CENTRAL VALLEY NATURAL GAS STORAGE PROJECT	VARIANCE REQUEST FORM	
---	--------------------------------------	---

Date Required:	Original Date: November 18, 2011	Variance Request No.:	No. 15 – Increase of Hazardous Material Stored at Compressor Station Site
Date Submitted:	Original Submittal: November 9, 2011 Resubmitted: February 8, 2012 with new variance number per CPUC request	Location:	Compressor station site located on McAusland Road
Property Owner(s):	Glassgow	Parcel No.:	012-110-095
Current Land Use:	Site is developed and supports the compressor station facility.	Sensitive Resources:	None.

Variance from: This variance requests the CPUC’s approval to increase the size of tanks and quantities of hazardous materials that will be stored at the compressor station. Table 5.8-2 in the IS/MND contains a list of hazardous materials that may be stored at the compressor station site. This table was based on the best available information at the time the IS/MND was prepared. The most current estimate of quantities required is different than what was originally estimated in the IS/MND. The tank sizes and associated maximum fill capacity are provided below in red and original IS/MND esti

Reactant Tank Layout System Interconnect

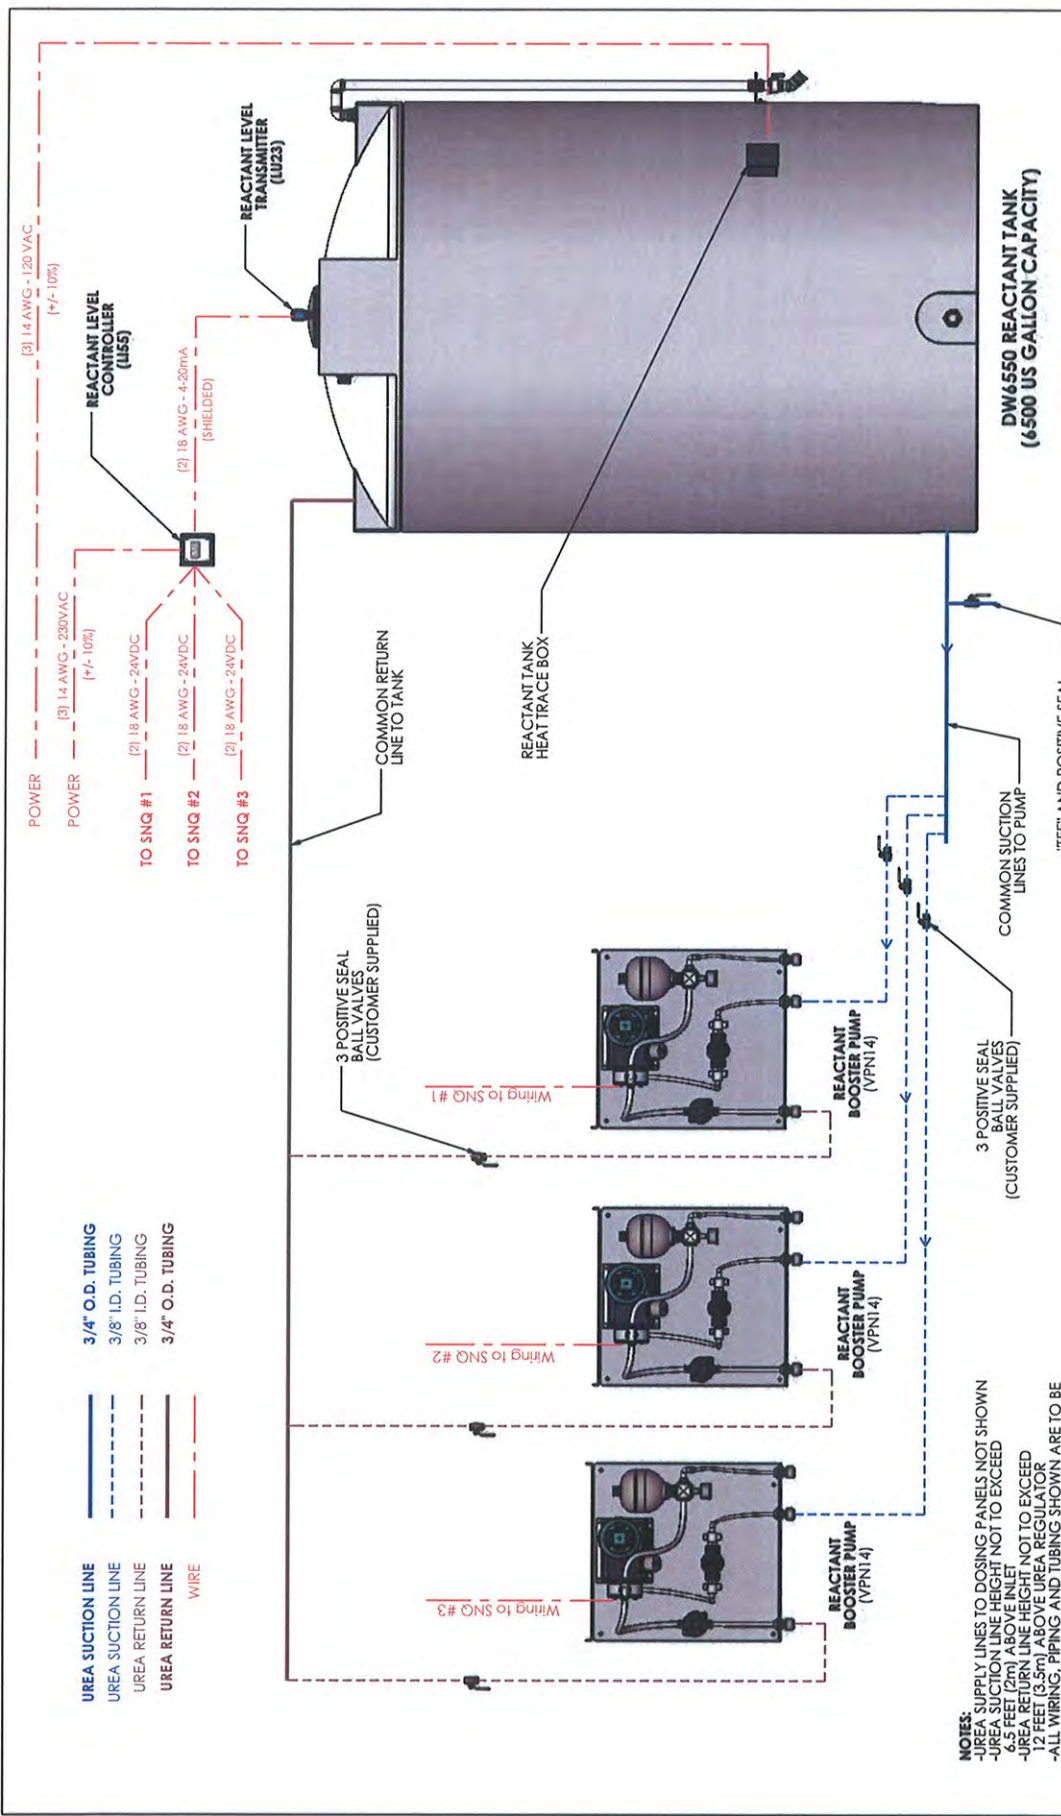
From: Bushnell-Bergfalk, Susan <SBushnell-Bergfalk@icfi.com>
Sent: Wednesday, January 25, 2012 10:50 AM
To: Scott Eckardt
Cc: James Kiefer; John Boehme; David Hochart; Chiang, Eric
Subject: Varaince #14 - Additional Information for the Urea and Transfer Tanks
Attachments: 105056-T3-R6 Model (1).pdf; Urea_DWGs.pdf; Tank Location Exhibit of CVGS1-S-101-01_1-10-12.pdf

Urea Tank 6 500 gallons and approximately 10' diameter x 9' high
Transfer Tank 380 gallons and approximately 4' diameter x 5' high

COMPRESSOR STATION FOUNDATION LOCATION PLAN SHEET 1

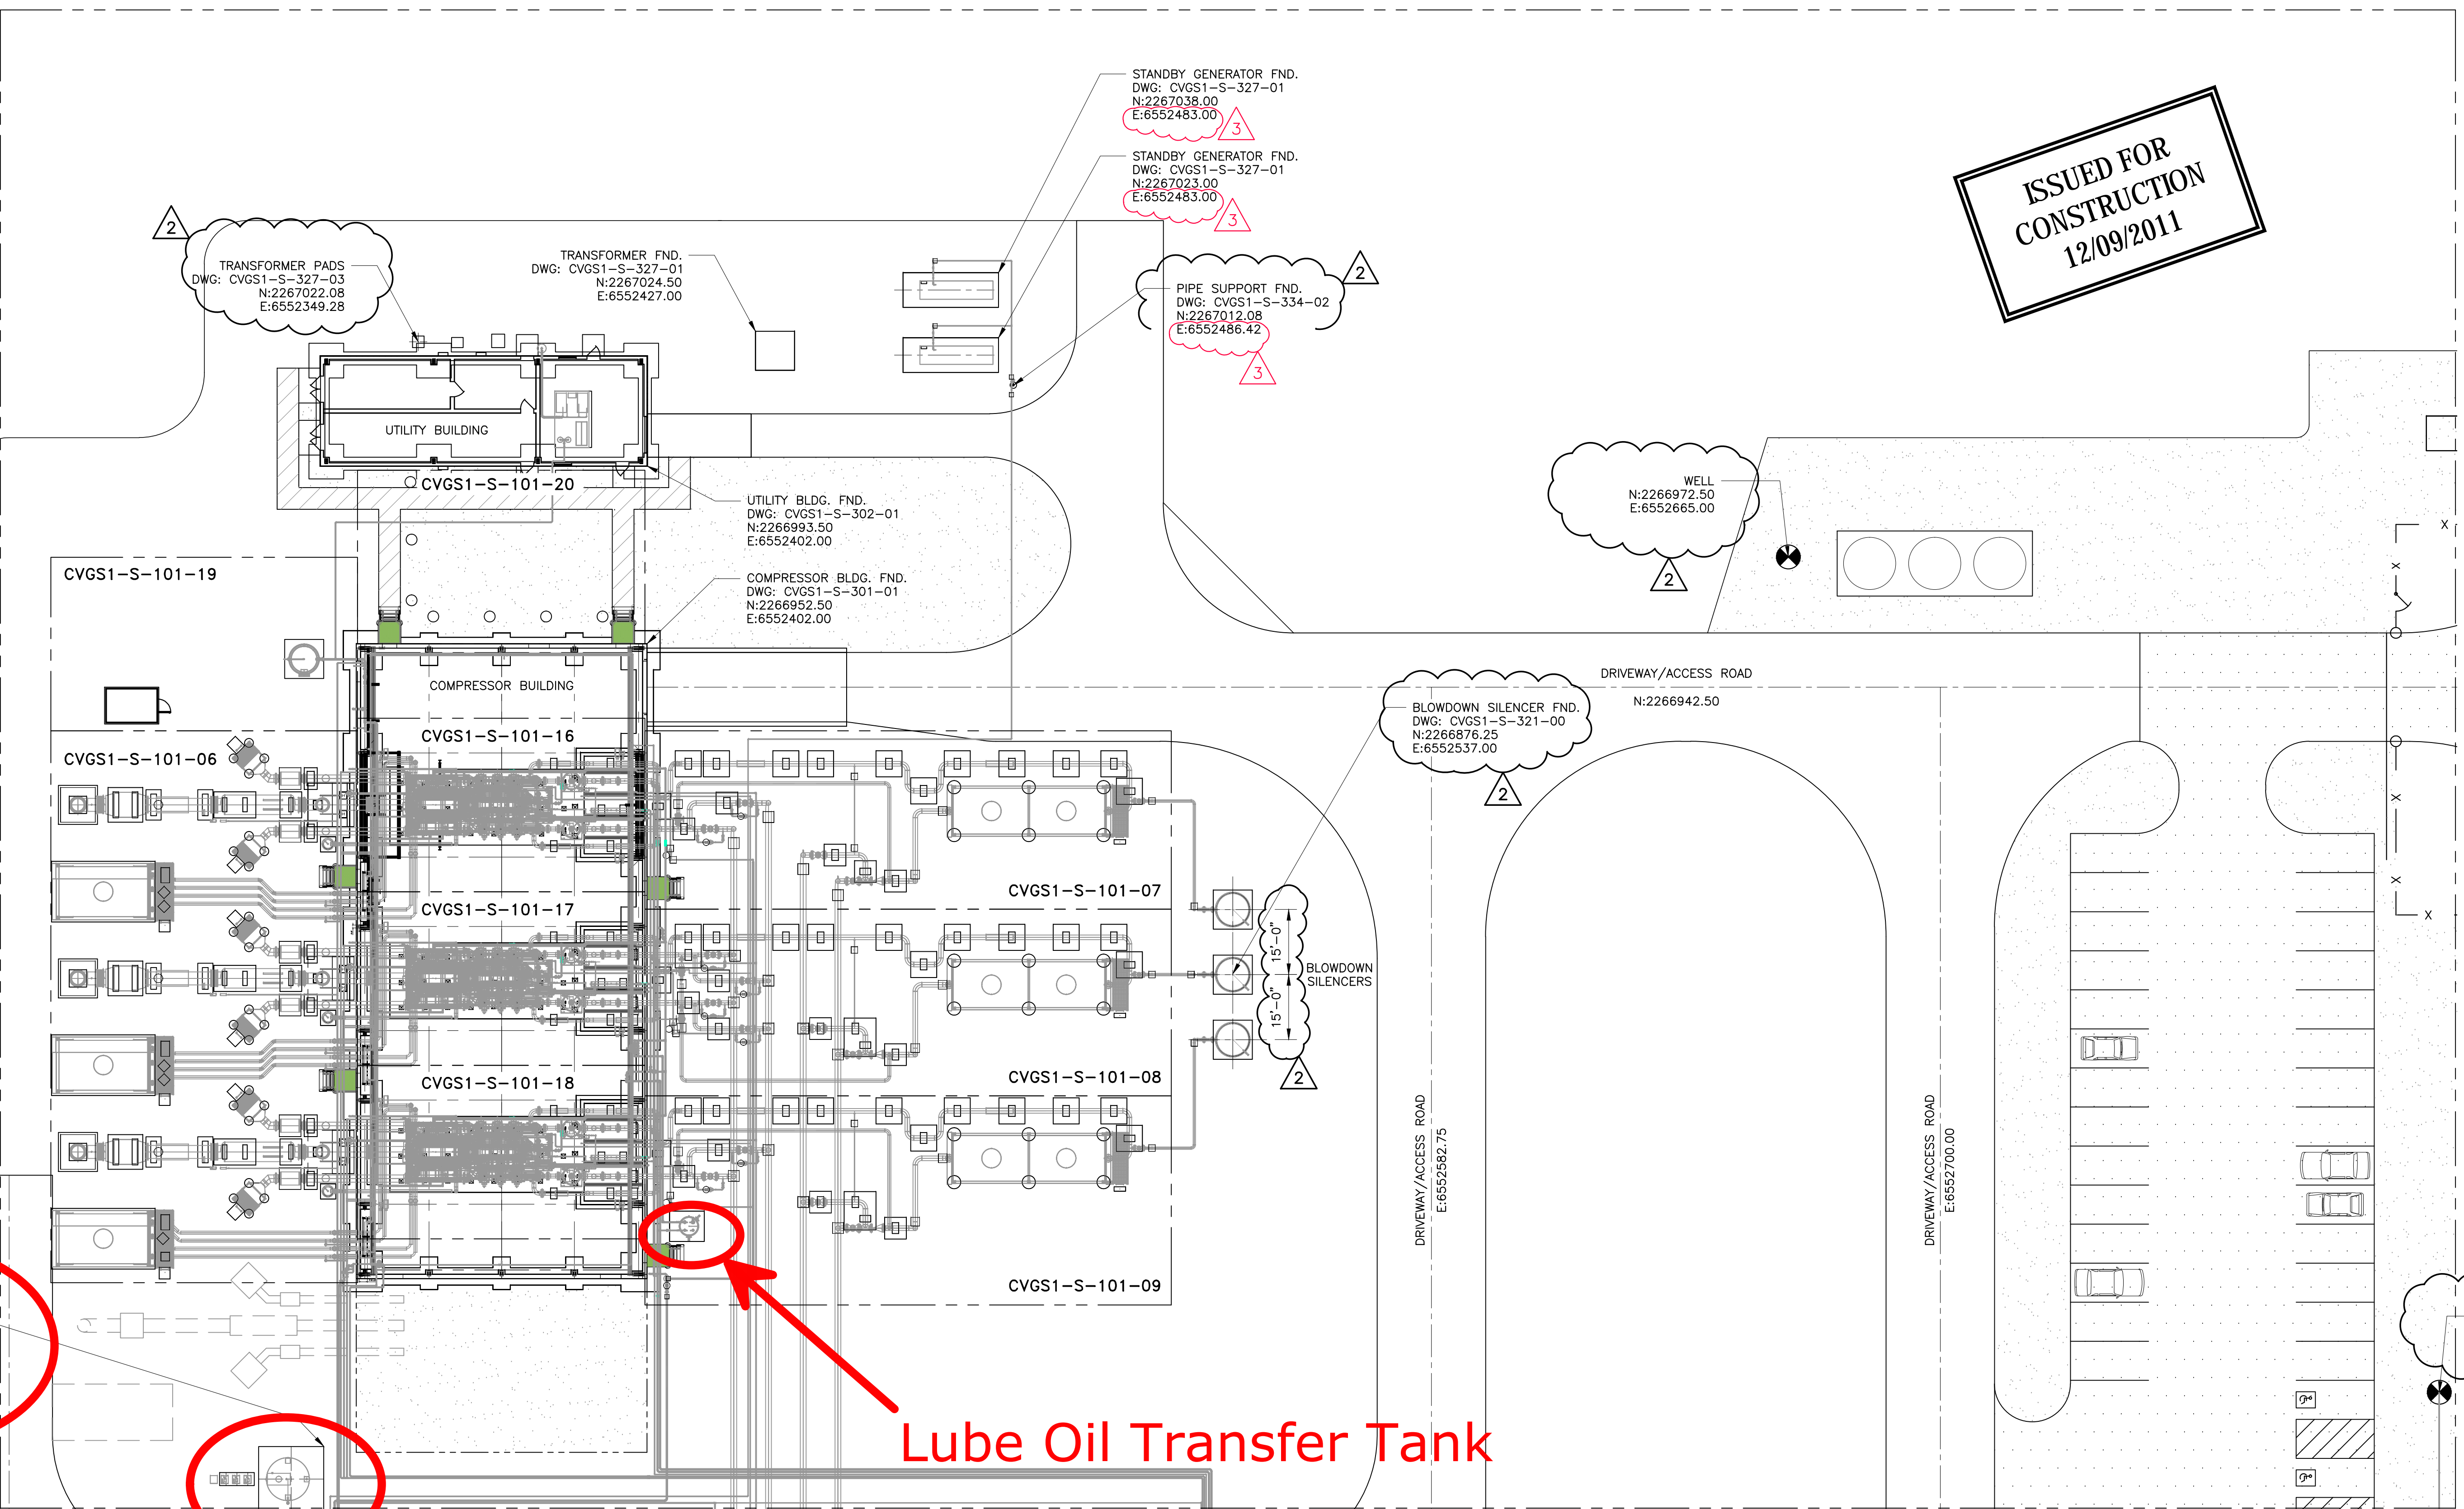
- 1) Please provide the dimensions and precise location of the tanks that will be constructed onsite. The description should include the materials and coloring of the tanks.

- o Tank dimensions are in the following response.
 - o Tanks are located [on the drawing attached.] Tanks location was modified at the request of operations personnel. Delivery of liquids at the original tank location would have potentially blocked access to the facility during the delivery. The new location is located on an internal plant loop, and does not have the potential of blocking traffic. Further, the proposed tank location is substantially behind buildings, and visibility off site will be limited.
 - o Tank construction will be carbon steel, all welded.
 - o Tank color will be similar to all pipe and buildings, which is a earth tone shade.
- 2) Please clarify whether the tanks will be single-walled or double-walled. In the event single-walled tanks are proposed, please provide the dimensions and footprint of the containment area.

As you requested, we are providing additional information on the urea and transfer tanks. The tanks are located at the compressor station near the Southern edge of the Compressor building (see attached "Tank Location Exhibit").

Urea Tank Southwest Corner of Compressor Building N 2 266 760.00, E 6 552 320.00
Transfer Tank Southeast Corner of Compressor Building N 2 266 818.00, E 6 552 412.00

Lube Oil Transfer Tank
